PRODUCT INFORMATION BULLETIN # 161810 FIRE - RSL

Issue date: 16 Oct 2018
Bulletin number: 161810

Subject: SWS Fire RSL system

Figure 1

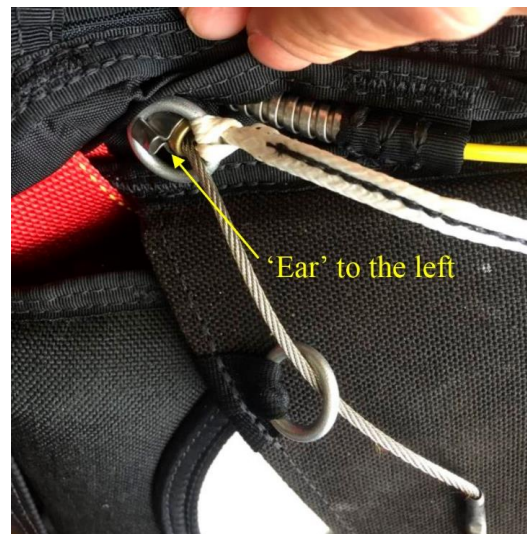
In September 2018 several BPA riggers applied to SWS company being worried about the possibility of the RSL ring to snag on the “ear” of the reserve cable housing, in case if the “ear” turns to the left.

1. To prevent this from happening we recommend the following:

Using a seal thread to tie ring on the RSL to the guide ring on the reserve flap with a single wrap of the thread, as shown in figure 3.
